SP202300021 Flow Hyundai
Outdoor Storage, Display, and Sales
SE202300046 Flow Hyundai Special
Exception

Albemarle County Board of Supervisors
Public Hearing
August 7, 2024

SPECIAL USE PERMIT
 CONCEPT PLAN - EXHIBITS
FLOW HYUNDAI
PARKING ALLOCATION
 Sheet 5 of 7

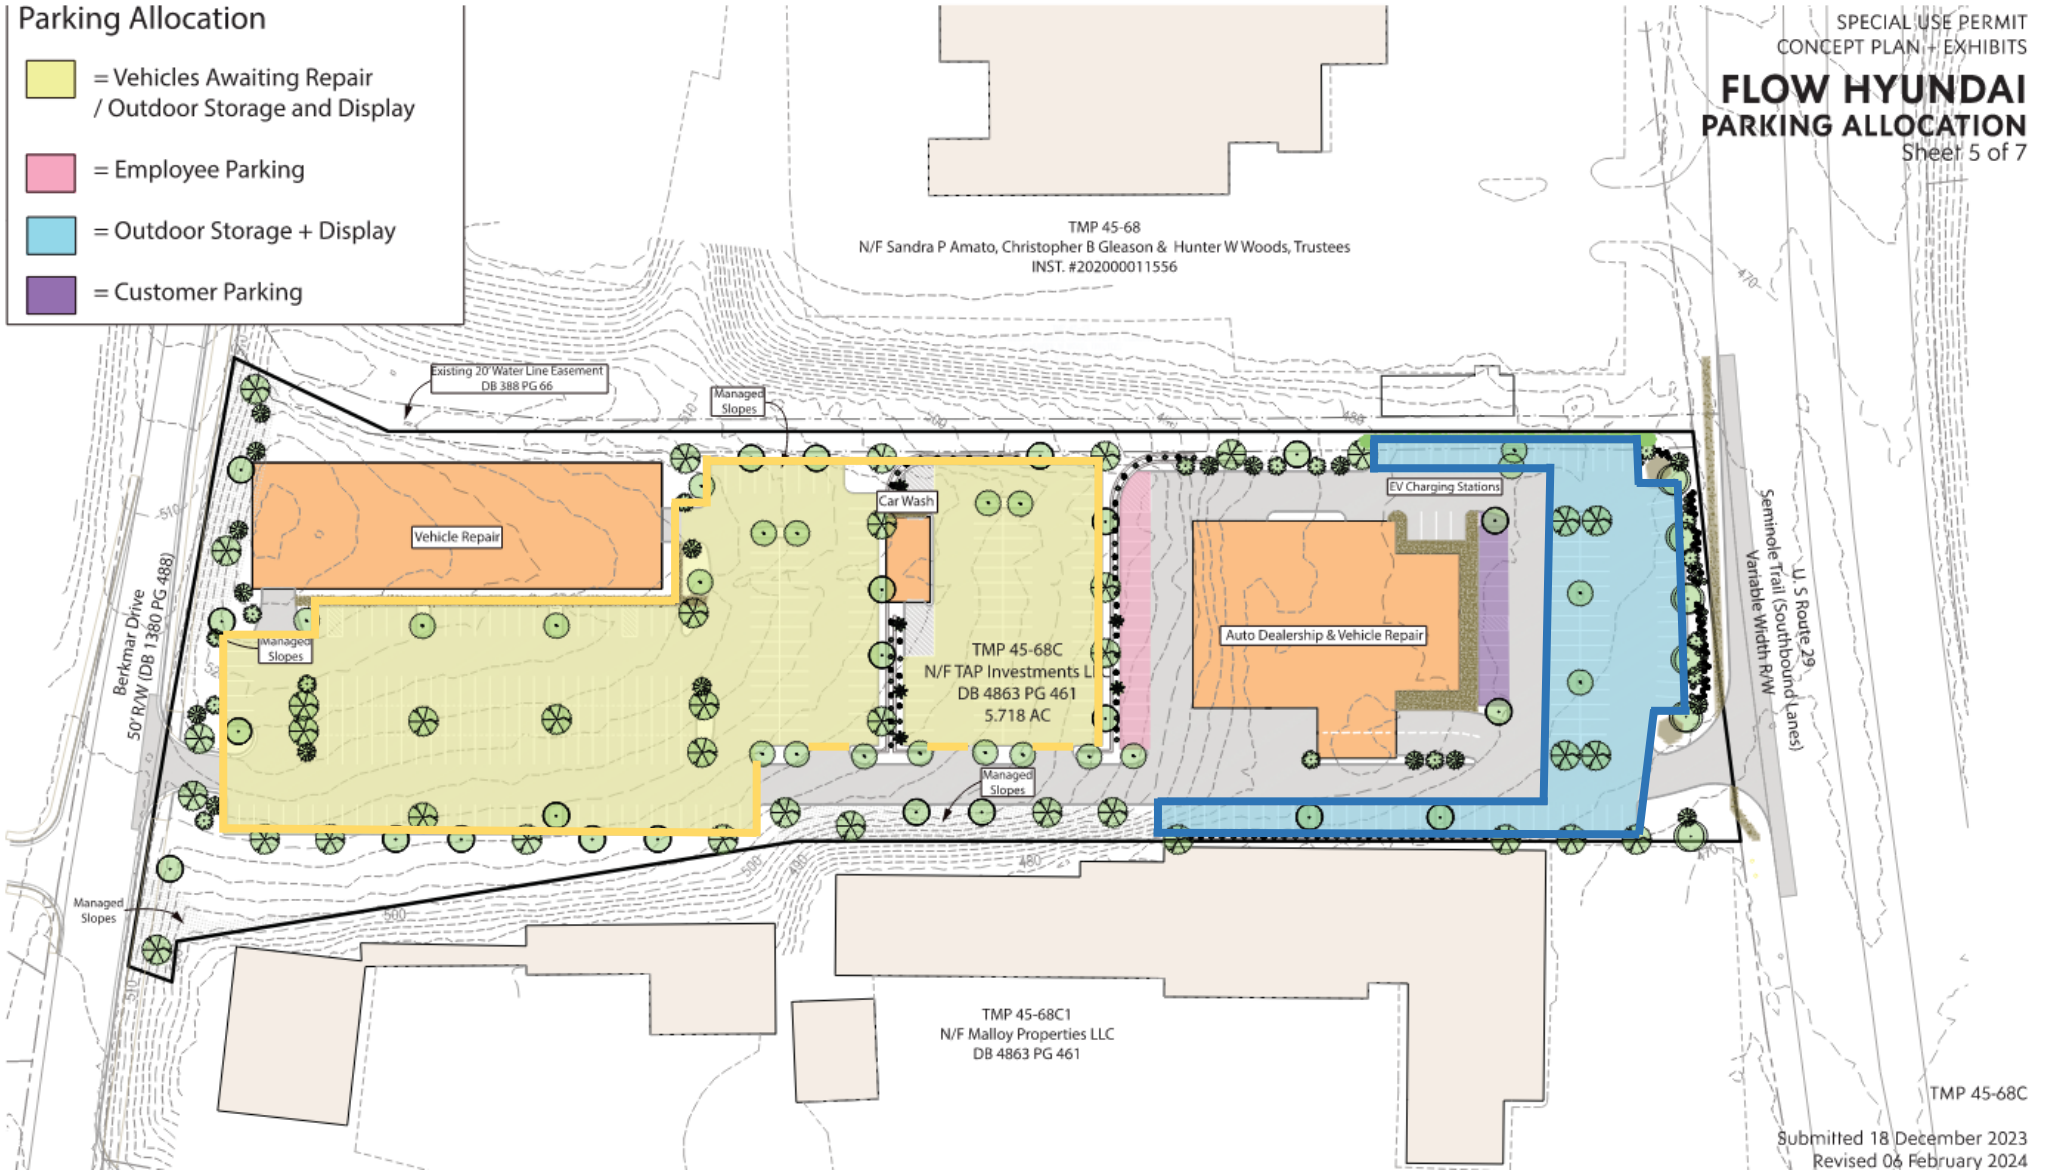
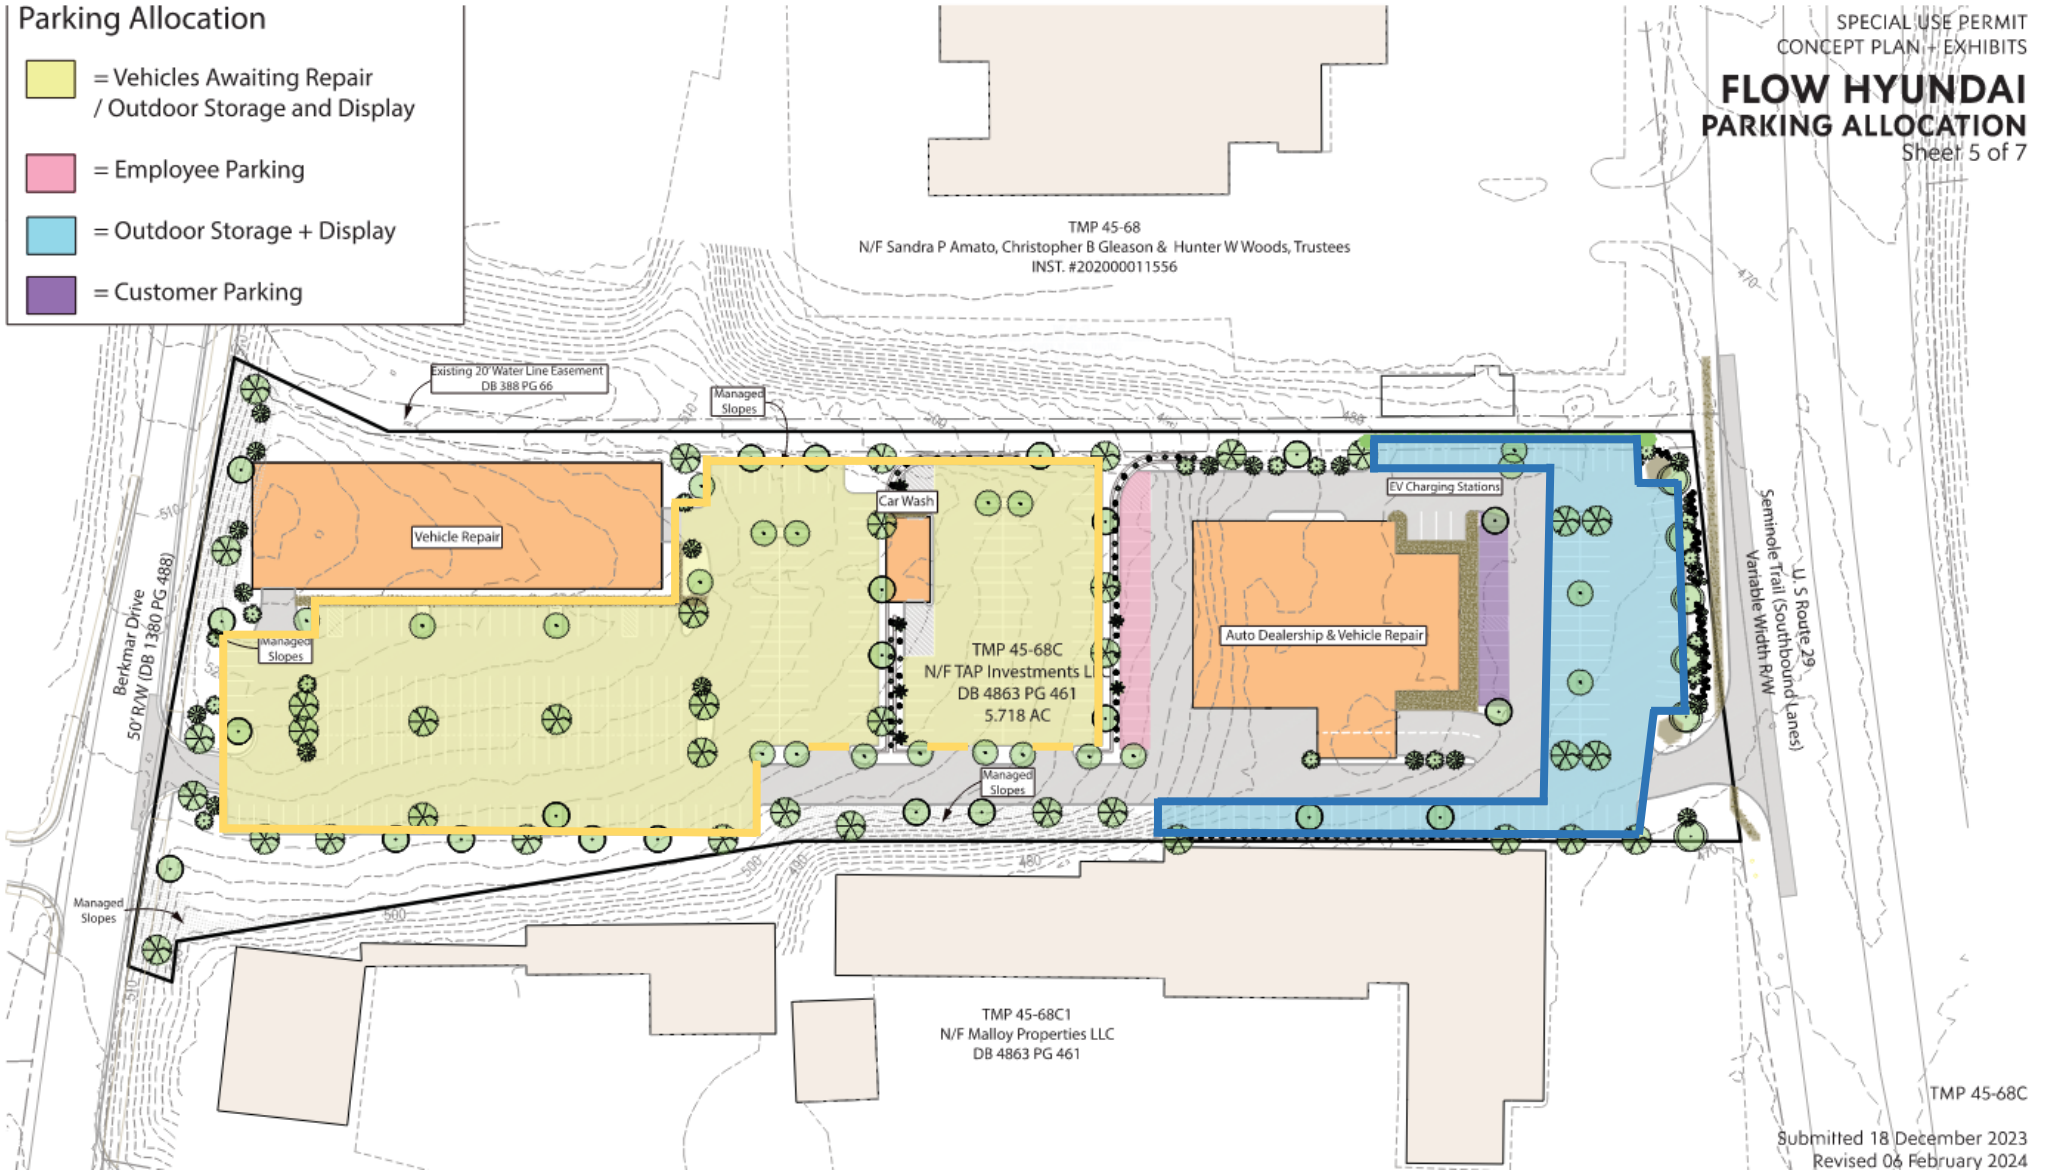
1. Use of this site must be in general accord with the Flow Hyundai Concept Plan + Exhibits by Shimp Engineering dated March 18, 2024. To be in general accord, **vehicles for sales, storage and/or display must be parked only in the spaces indicated for sales, storage and display on the Flow Hyundai Parking Plan.**

2. Vehicles for sales, storage and/or display **must be parked in striped parking spaces.**
3. Vehicles must not be elevated anywhere outside a building on site.

Visibility Analysis

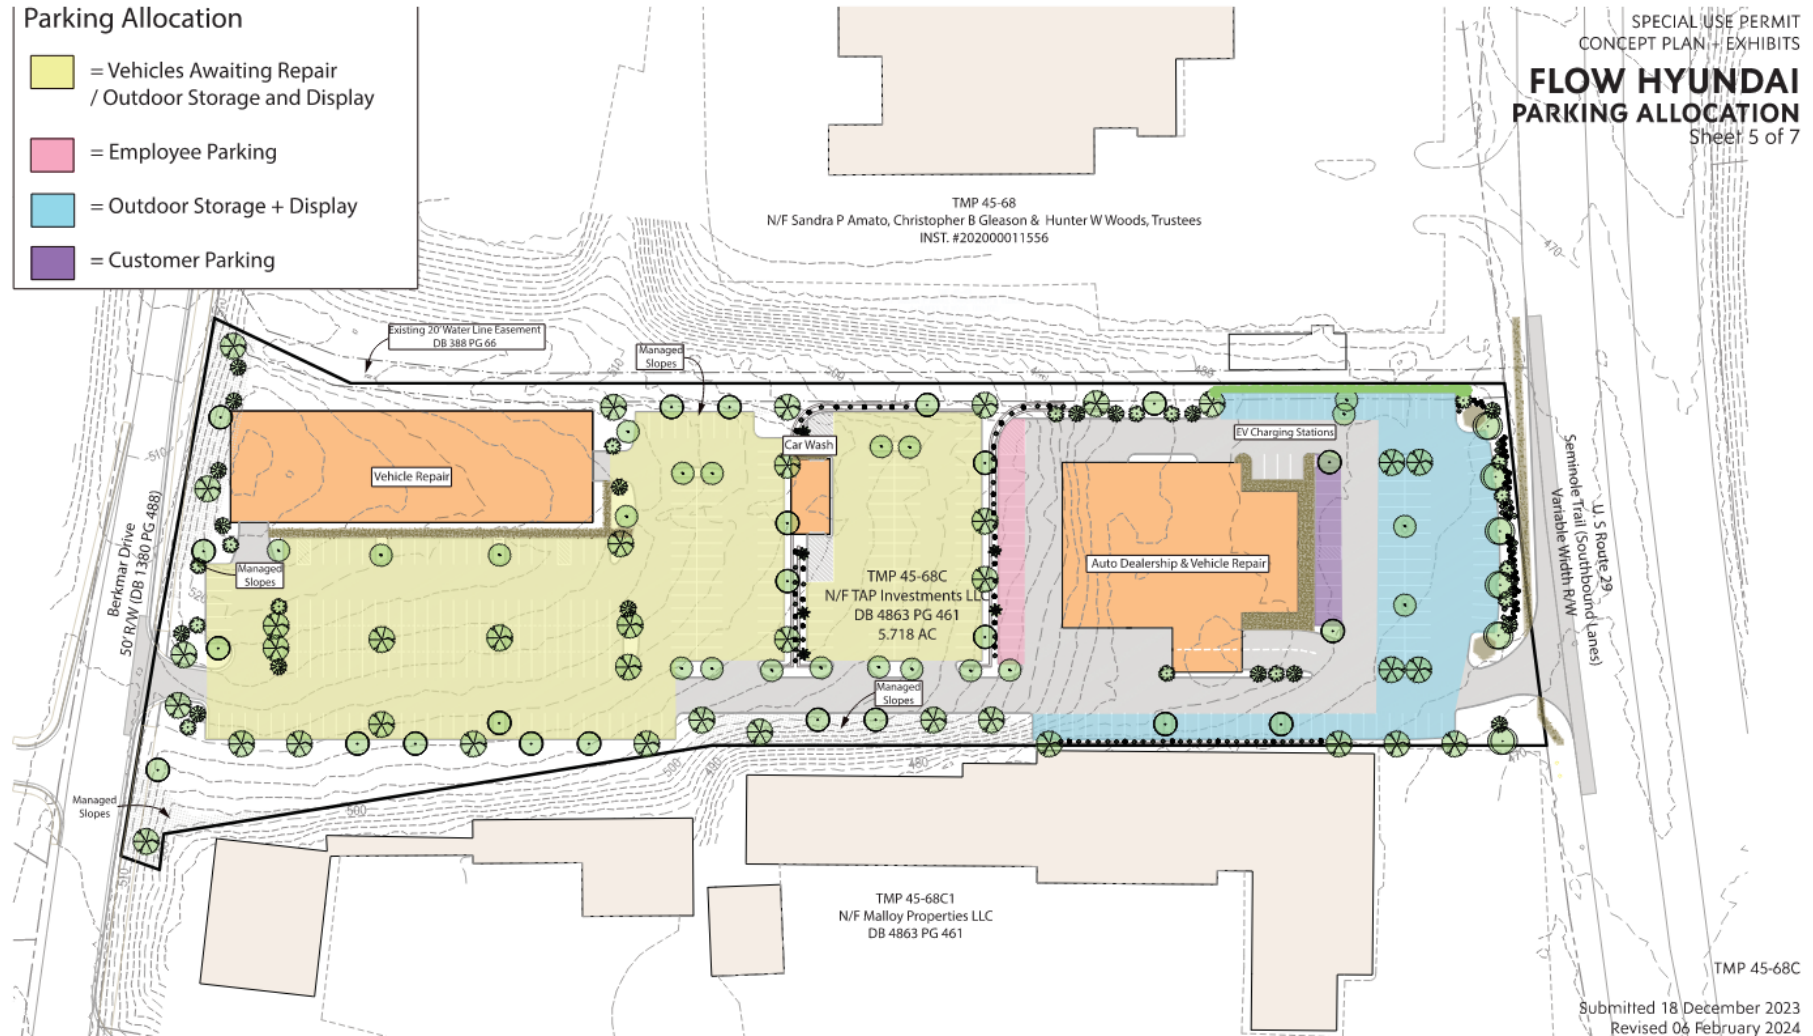
No vehicle awaiting repair shall be located on any portion of the site so as to be visible from any public street or any residential property and shall be limited to locations designated on the approved site plan.

Vehicles Awaiting Repair

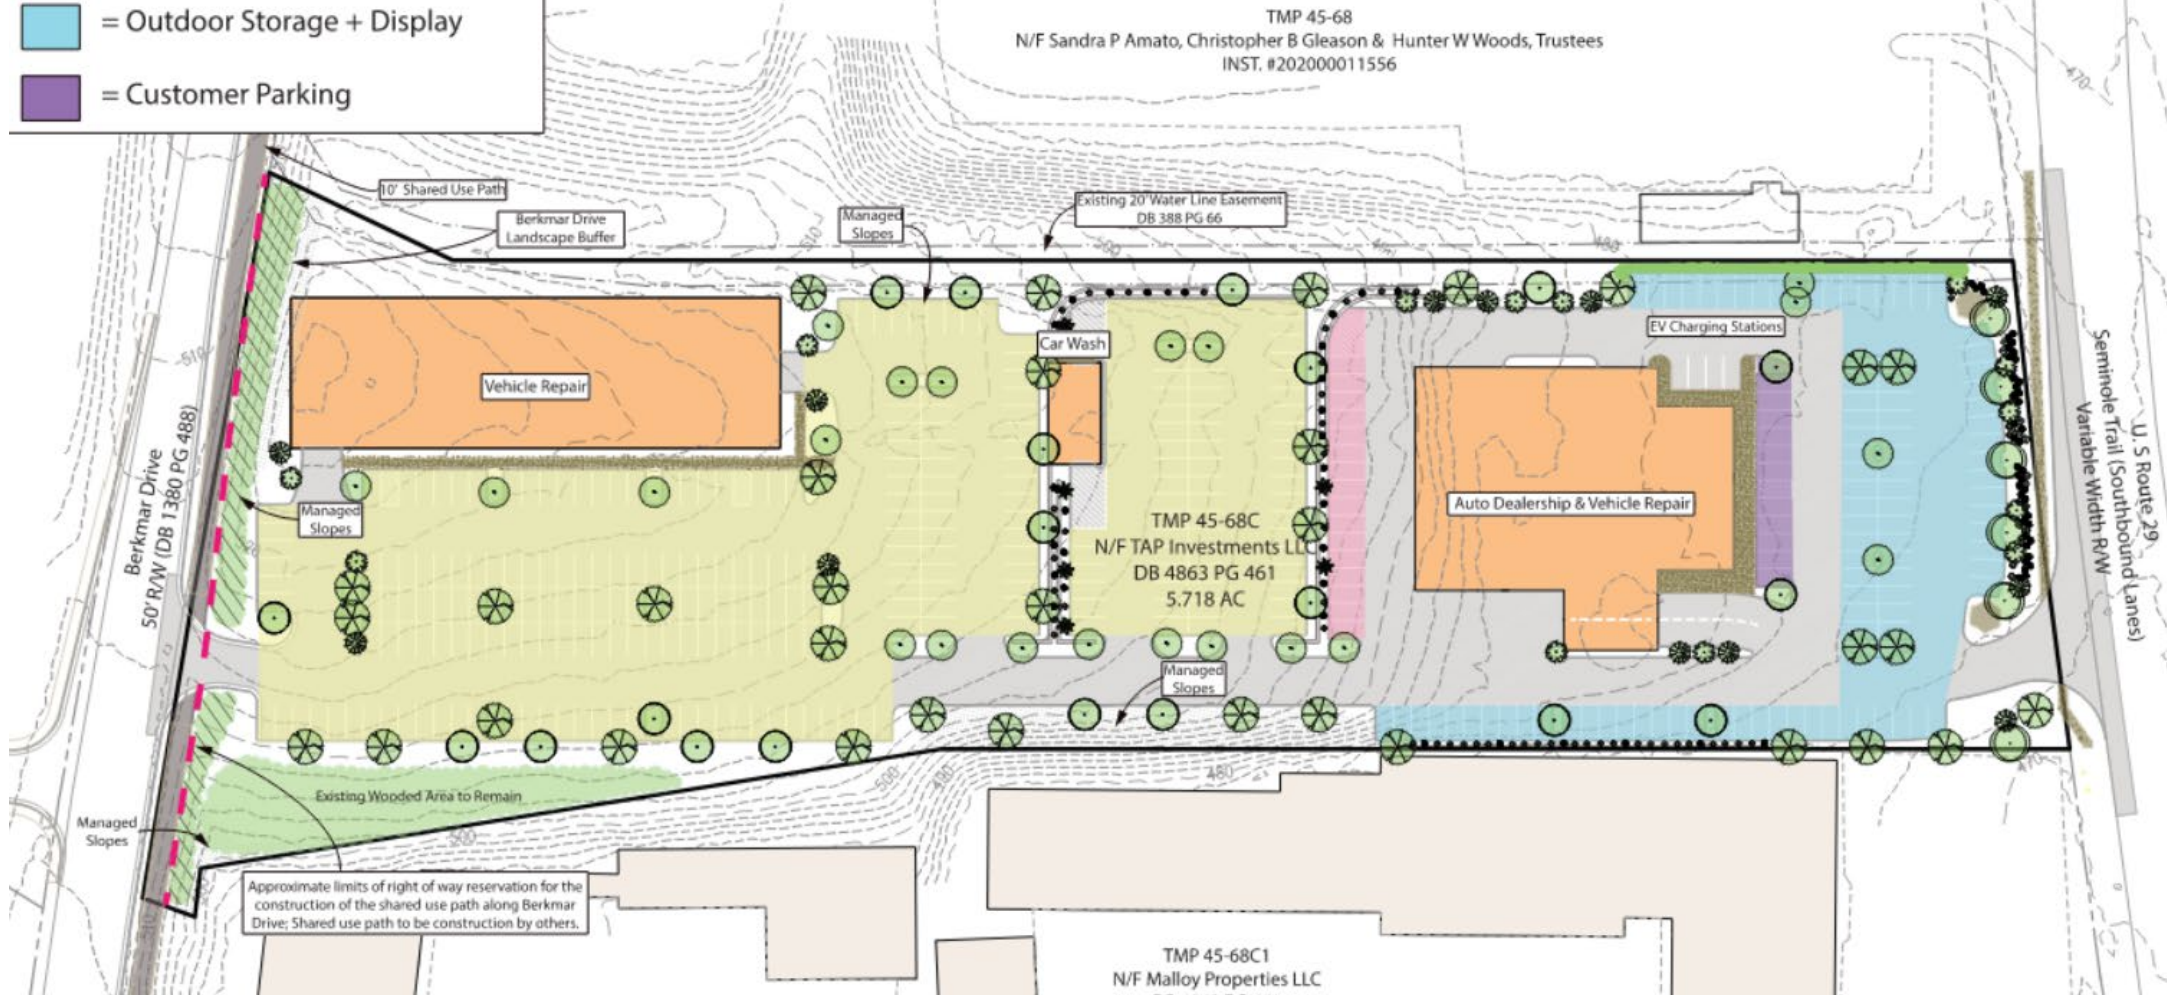
The Commission recommended providing additional (and where possible, preserving existing) landscaping, including evergreens, along Berkmar Drive and at the perimeter and interior of the parking areas.

1. The final site plan must include a landscape plan that contains the following, to the satisfaction of the Director of Planning:
 - a. A landscape buffer adjacent to Berkmar Drive that considers the alignment of the future shared-use path, as indicated on the Flow Hyundai Concept Plan + Exhibits by Shimp Engineering last revised June 19, 2024, and screens parking areas for vehicles awaiting repair;
 - b. Landscaping in the buffer, meeting or exceeding the requirements of *County Code* § 18-32.7.9, including a mix of large shade trees, flowering ornamental trees, evergreen trees, and evergreen shrubs; and
 - c. The wooded area remaining as identified on the Flow Hyundai Concept Plan + Exhibits by Shimp Engineering last revised June 19, 2024.
